Airworthiness Criteria: Airship Design Criteria for Zeppelin Luftschifftechnik GmbH Model LZ N07 Airship

ACTION: Notice of issuance of final design criteria.

Figure 3: Dihedral Angles for Position Lights

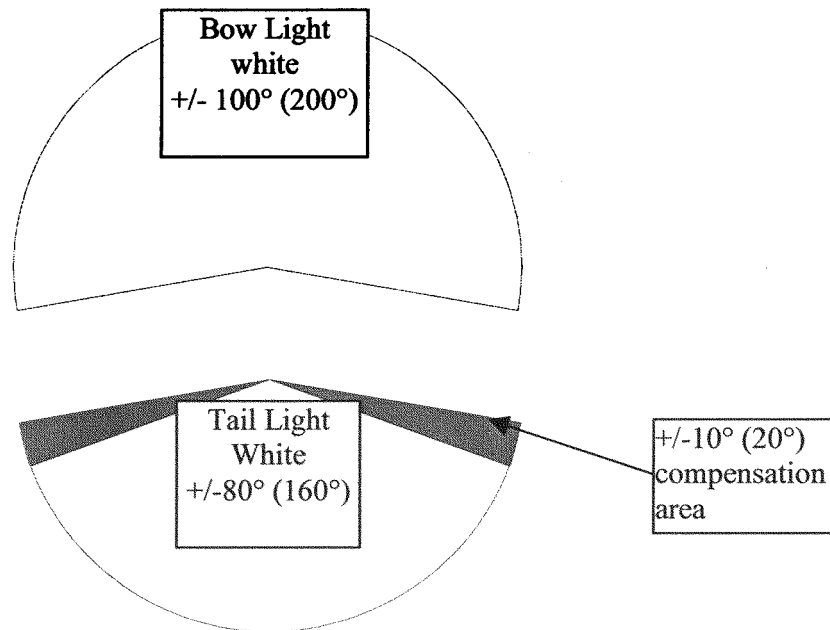
LFLS Section 2498(b) and ADC Paragraph 6.25—Position Lighting

LFLS Section 2498(b) and ADC paragraph 6.25 specify the position lighting requirements for airships. It is not understood why a dispensation should be given for something that can be easily fixed with properly TSO’d LED or similar lighting. ABC had to go through a stringent certification of the lighting on the one model. This was revisited in a new model and the FAA

asked ABC to modify our position lighting by providing two sets of bow lights in slightly different positions to further ensure adequate brilliance in all sectors. It is not understood why any latitude is being given to this basic legal requirement affecting safe navigation of aircraft.

The FAA notes that there is no LFLS section 2498(b) and that the comparable LFLS section to ADC section 6.25 is LFLS section 1385. The only section where an equivalent level of safety to the LFLS lighting requirements was granted by the LBA is LFLS section 1387(b). The LBA granted this equivalency based on what was considered compensating features of the lighting system installed on the LZ N07-100, and the FAA agreed.

LFLS § 1387(b) requires a dihedral angle formed by two intersecting vertical planes making angles of 110 degrees to the right and to the left. LFLS appendix table 10 requires, in addition, a minimum light intensity of 20 cd throughout the dihedral angle. The LZ-N07 system only attains the required intensity over 100 degrees but is still visible from 100 degrees to 110 degrees (left and right) at a reduced intensity. The LBNA granted an equivalency to LFLS § 1387(b) based on the greater dihedral angle coverage of the aft light, +/-80 degrees rather than +/-70 degrees at the specified intensity. This is acceptable to the FAA.

The LFLS § 1387(b) required dihedral angle will be no less than 100 degrees at the intensities specified in Table 10 of the appendix of the LFLS. In addition, the rear light will have an included angle of +/-80 degrees at the specified intensity from Table 10 of the appendix of the LFLS. Refer to Figure 3.
